SUBJECT: Guilford County; Greensboro Eastern Loop from US 70  
Relocation to SR 2303 (Lawndale Drive);  
WBS No. 38421.1.1; **TIP U-2525B & C.**

Attached are modifications to the US Army Corps of Engineers Section 404 Individual Permit and NC Division of Water Resources Section 401 Water Quality Certification. Except as revised here, the permit conditions of the original U-2525 permits and subsequent modifications remain valid.

As a result of the 401 and 404 permit modifications issued March 18, 2016, the following special conditions were added due to modifications made near Permit Site 37 on U-2525B:

Also reference your letter to the Corps, received via electronic mail on March 9, 2016, requesting modification of the permit for additional impacts to U-2525B, including the permanent discharge of fill material into 55 linear feet of stream channel and the temporary discharge of fill material into 0.05 acre of riparian wetlands, associated with:

**SHEET 38A1**  
added March 9, 2016

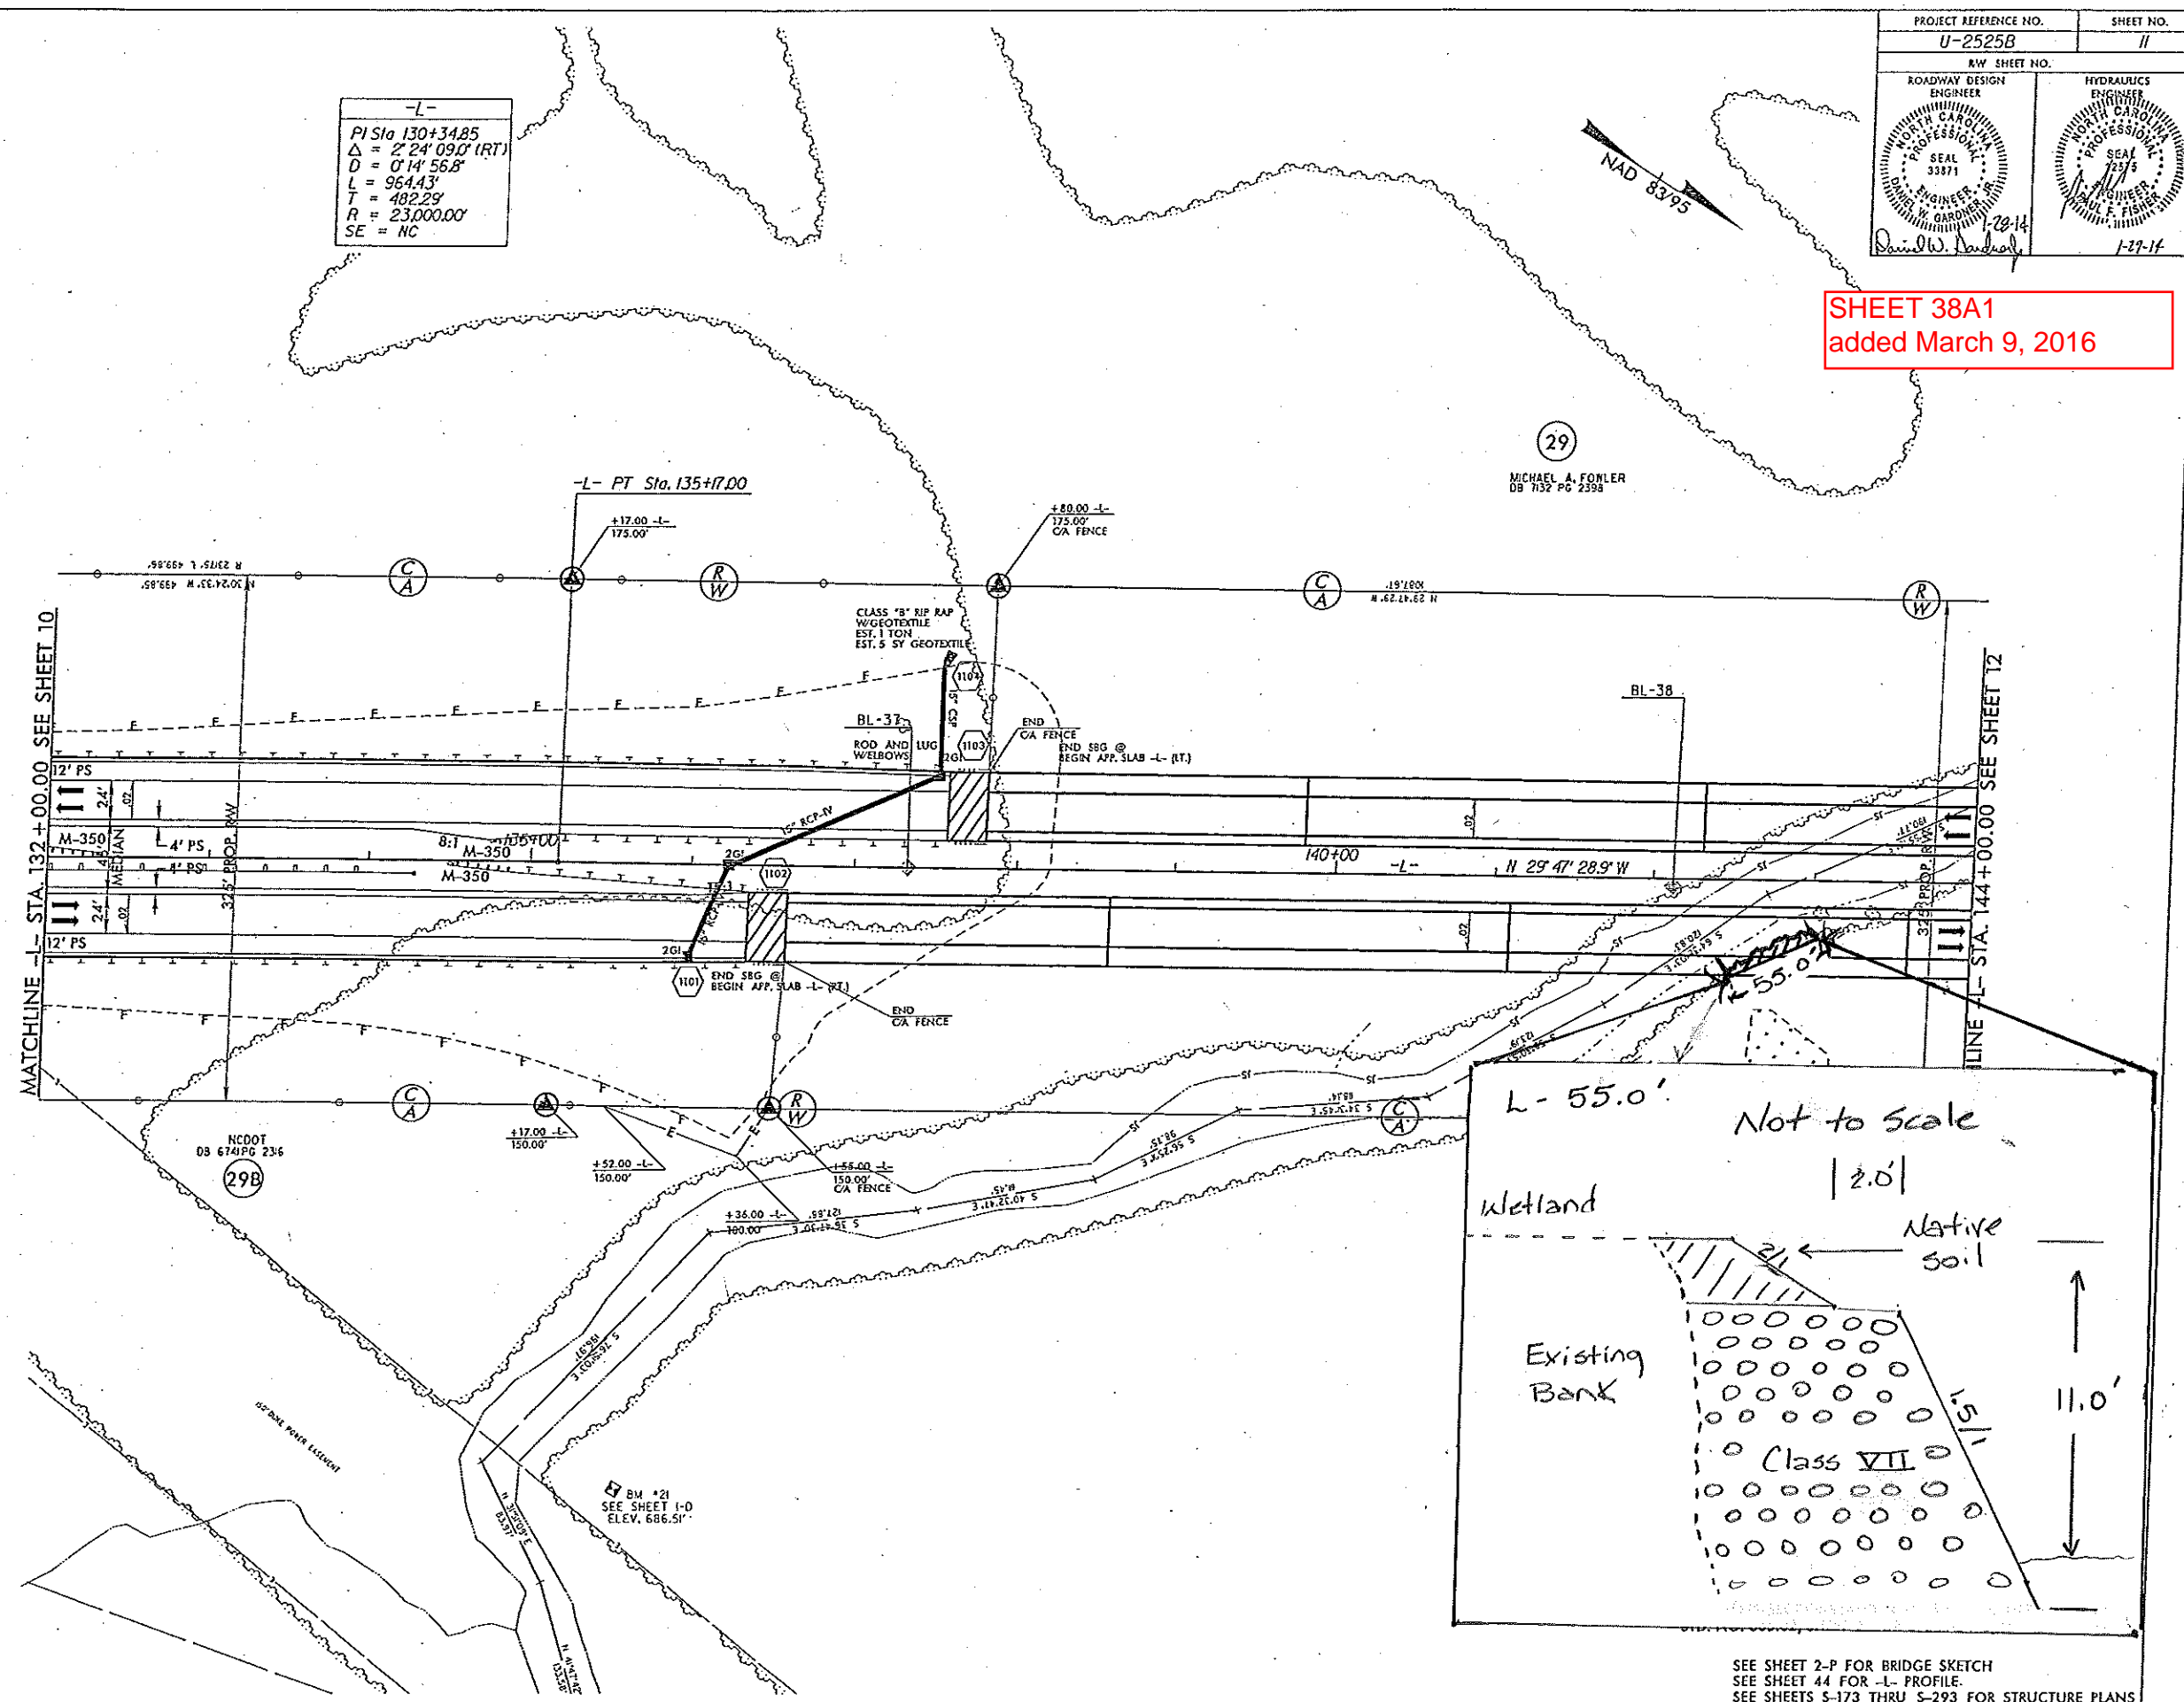
- 1) adding 55 linear feet of rip rap bank stabilization to the north bank of North Buffalo Creek at Permit Site 37, to correct severe bank erosion occurring immediately downstream of a temporary construction access crossing authorized by the March 12, 2015 Permit Modification; and
- 2) adding 0.05 acre of temporary impacts to a wetland adjacent to North Buffalo Creek, necessary to provide construction access to install the additional bank stabilization.

**SHEET 38A2**  
added March 9, 2016

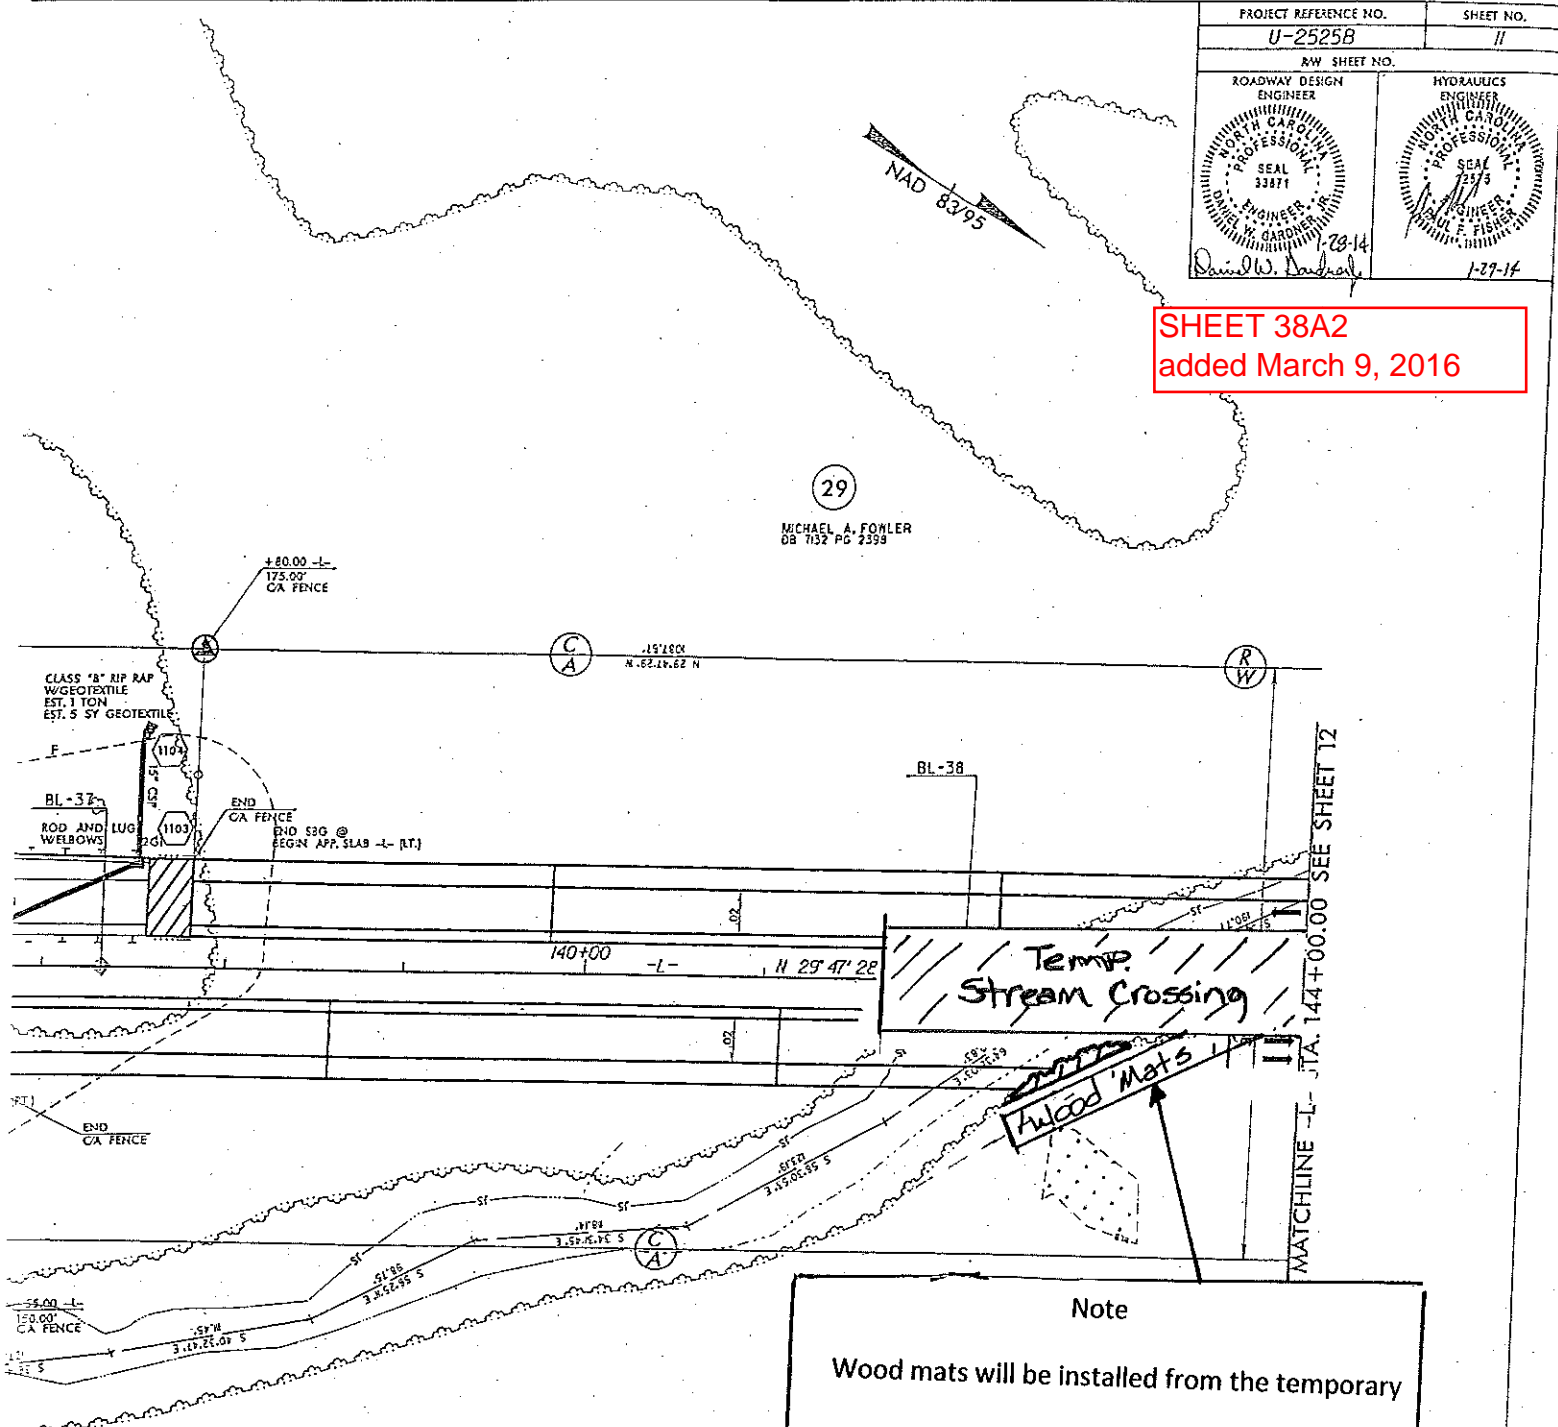
404 Condition x: Within three days of the conclusion of bank stabilization installation described herein, the temporary wetland impact area shown on permit drawing Sheet 38A2 must be restored by re-establishing the pre-impact grade and contour, ameliorating

x) Within three days of the conclusion of bank stabilization installation described herein, the temporary wetland impact area shown on permit drawing Sheet 38A2 must be restored by re-establishing the pre-impact grade and contour, ameliorating areas of soil compaction by disking or similar means, and seeding with wetland seed mix comprised of native species.

Wood mats will be installed from the temporary stream crossing to the end of the eroded bank. The work will be performed from the mats. The mats will be removed as the track hoe leaves the area with no permanent impact to the wet land.

areas of soil compaction by disking or similar means, and seeding with wetland seed mix comprised of native species.
